**CALIFORNIA COASTAL COMMISSION**

REGULAR CALENDAR  
STAFF REPORT AND PRELIMINARY RECOMMENDATION

Application No.: 6-00-80

Description: Construction of a 27-foot high, 8,200 sq. ft. single family residence with detached garages, driveways, pool, and 800 sq.ft. second unit. Also proposed is a 25-foot wide public access easement and an average 102-foot wide open space setback from the lagoon. Approximately 3,261 cu.yds. of after-the-fact grading is proposed.

EXHIBIT NO. 2  
APPLICATION NO.  
6-01-080  
Site Plan

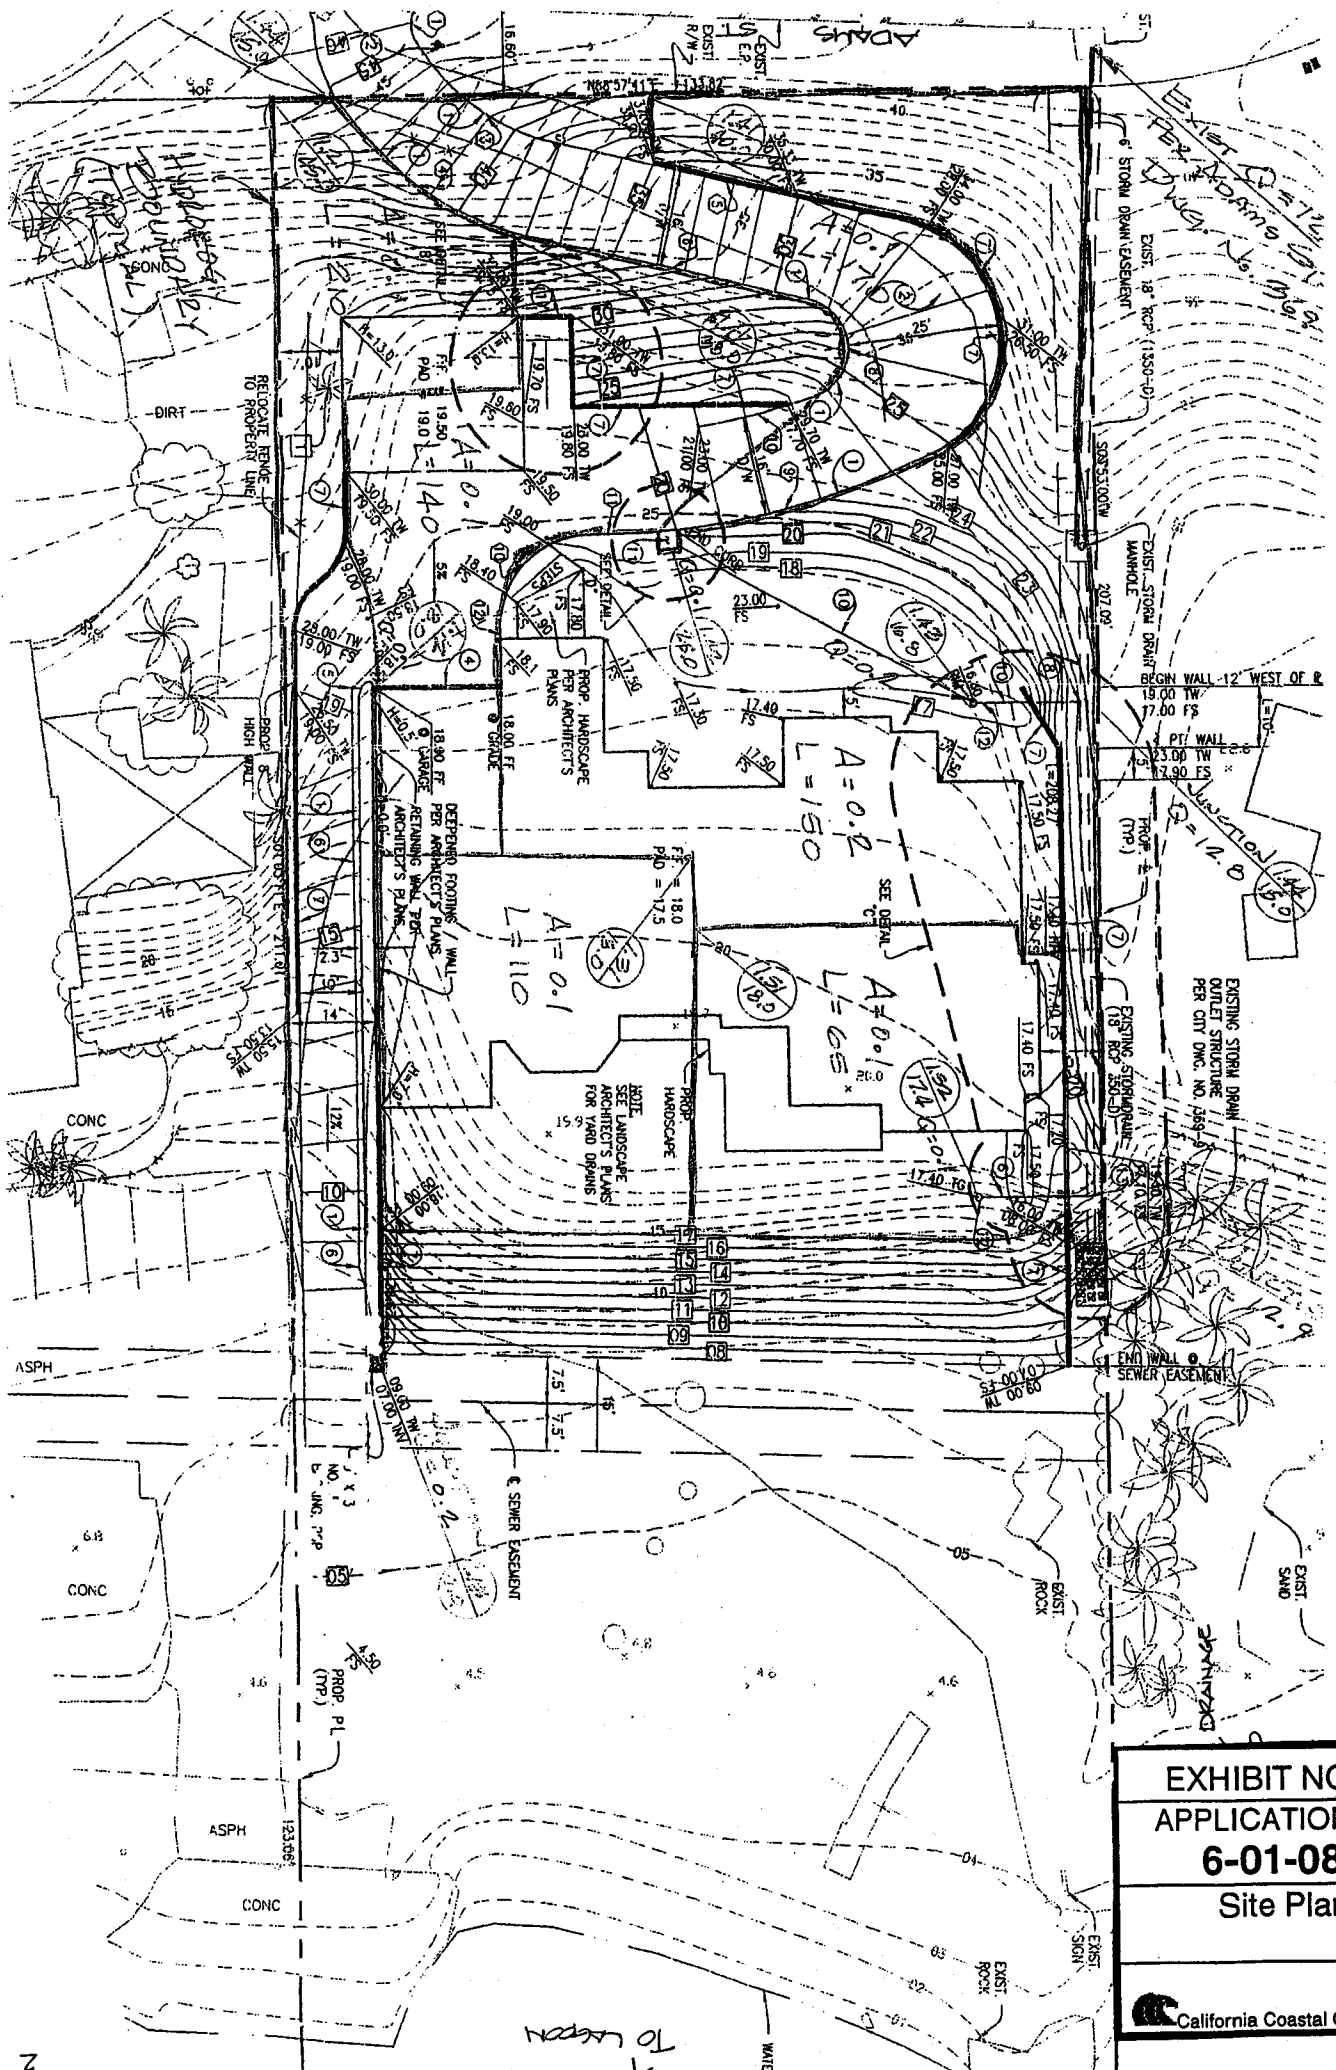
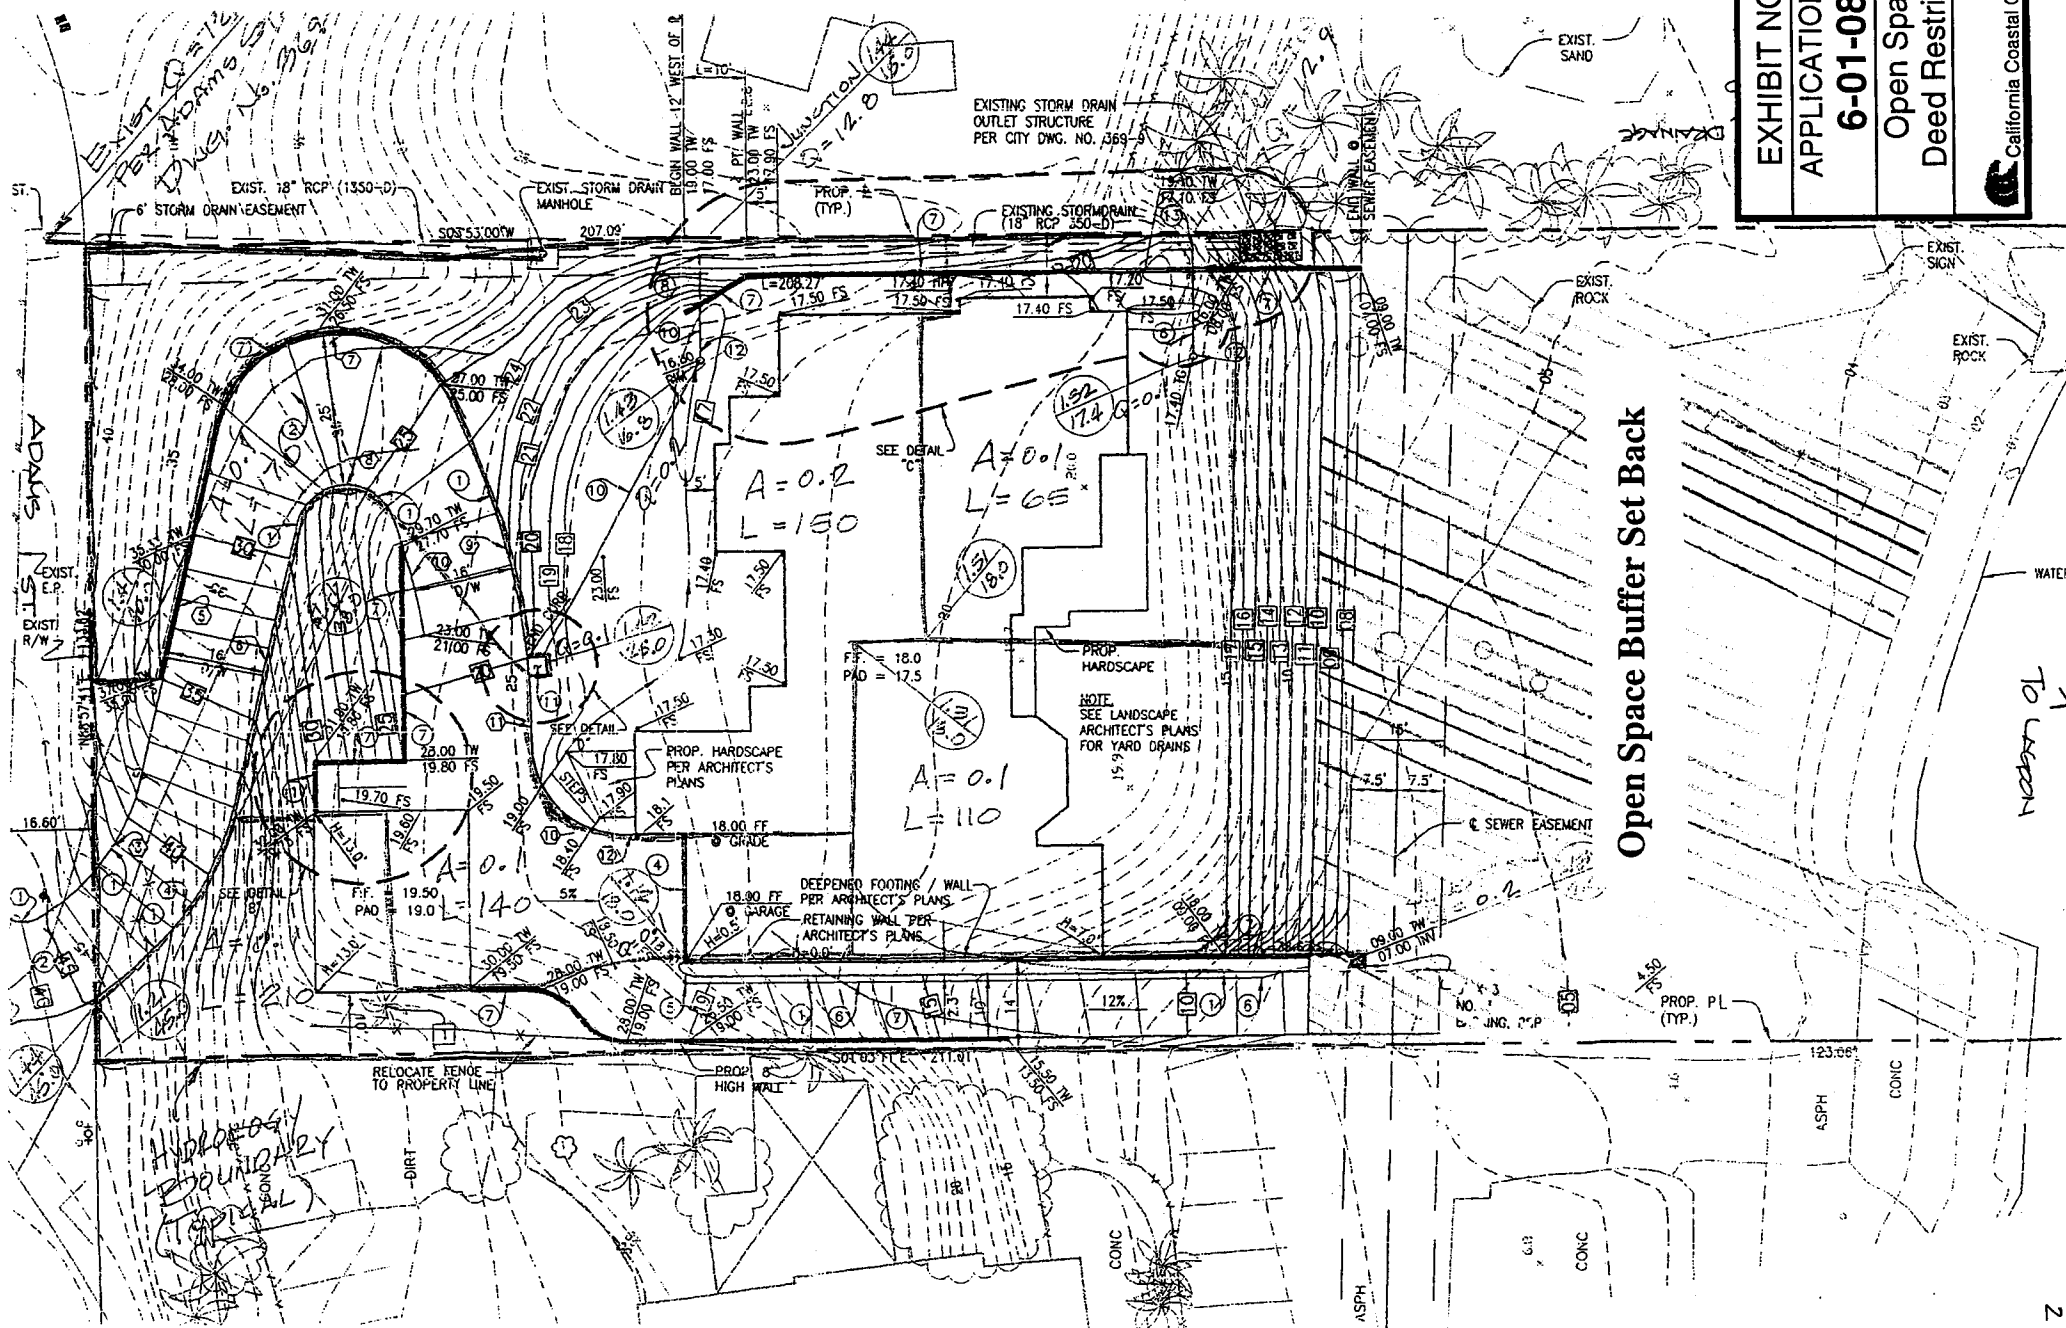
- a. The proposed rip rap drainage swale located within the beach portion of the open space buffer shall be deleted; riprap disposal at the terminus of the drainage pipe on the property may be permitted. A revised plan shall be submitted to limit the erosion in a manner that requires less rip rap.
- b. No improvements within the area subject to the public access easement shall be permitted. Public access trail improvements shall be determined in the future and require an amendment to this permit or a separate coastal development permit.

- e. The proposed rip rap swale on the beach within the buffer shall be deleted from the plans.

Regarding the public storm drain on the eastern side of the site, the applicant is proposing to install riprap in a swale located in the buffer downstream of the energy dissipater associated with the public storm drain. This swale was created by runoff not being effectively handled by the existing rip rap dissipater at the discharge of the storm drain (the existing rock has been unable to reduce the velocity of the water leaving the storm drain pipe to prevent downstream erosion in the buffer). While the Commission recognizes the problem that has resulted from the inadequately operating energy dissipater, it can not find that the up to 10-foot wide and 70-foot long rip rap lined swale located across the beach within the buffer is acceptable. The Commission finds a revised plan must be submitted to limit the erosion in a manner that requires less rip rap subject to Executive Director approval. In any event, while the Commission may allow some additional riprap to be placed within the buffer to correct the erosion problem, it cannot support the applicant's proposal to install riprap within the swale at this time. Special Condition #1 requires revised plans indicating the deletion of the swale and riprap.

EXHIBIT NO. 4
APPLICATION NO.
<b>6-01-080</b>
Public Access Easement
California Coastal Commission

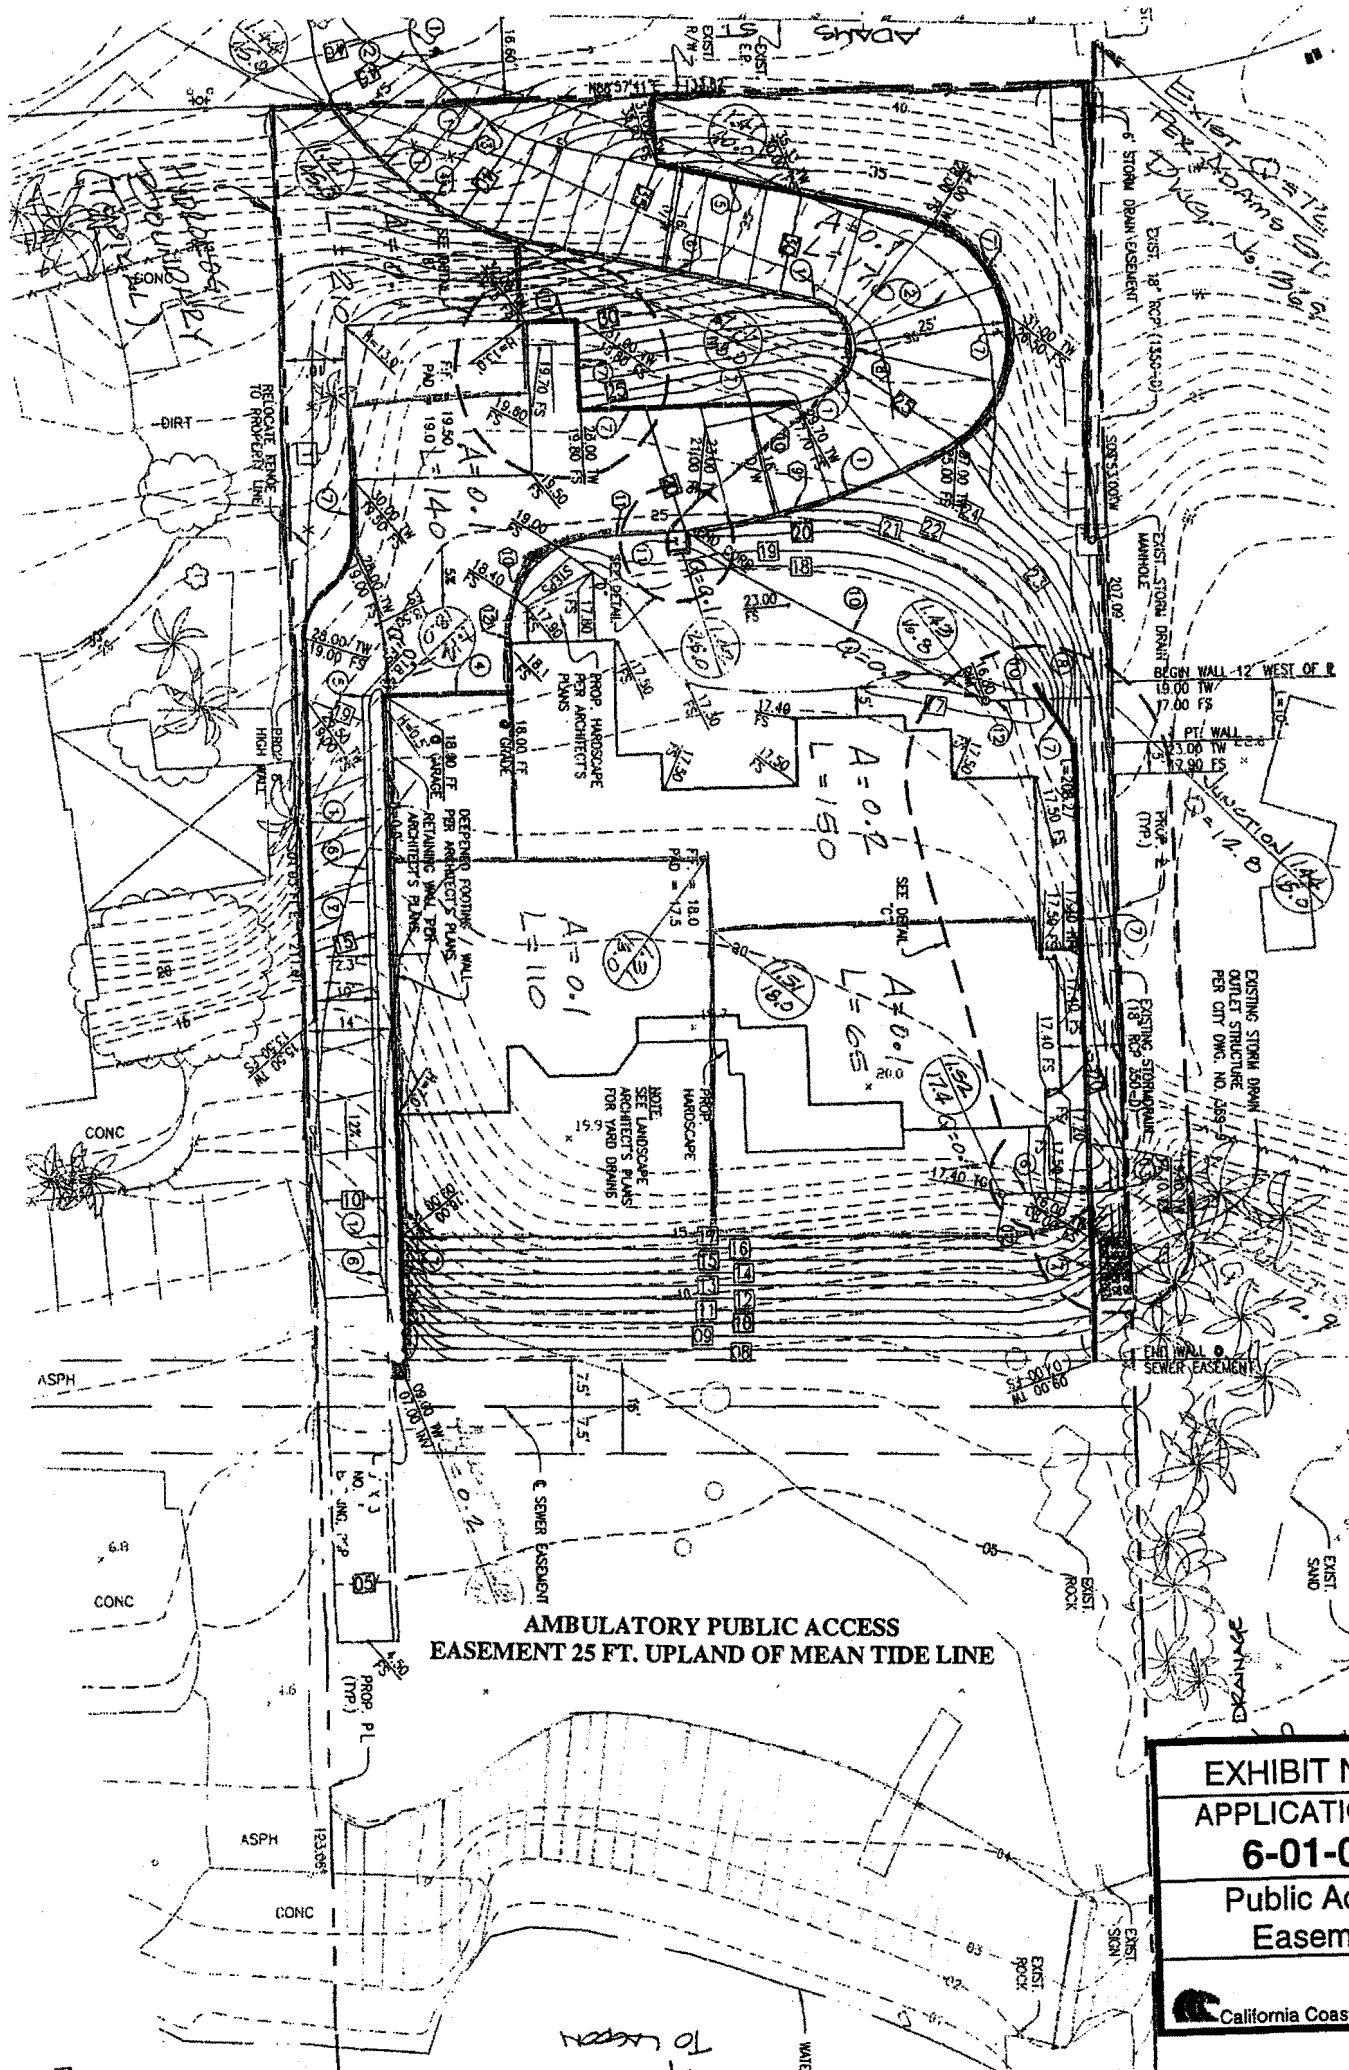
2. Lateral Public Access. PRIOR TO THE ISSUANCE OF THE COASTAL DEVELOPMENT PERMIT, and as proposed by the applicant, the applicant shall execute and record a document, in a form and content acceptable to the Executive Director, irrevocably offering to dedicate to a public agency or private association approved by the Executive Director an easement for lateral public access and passive recreational use along the lagoon shoreline. The easement shall be located along the entire width of the property along the Agua Hedionda Lagoon shoreline and shall extend 25-foot upland of the mean high tide line (2.0-ft. MSL) which is understood to be ambulatory from day to day.
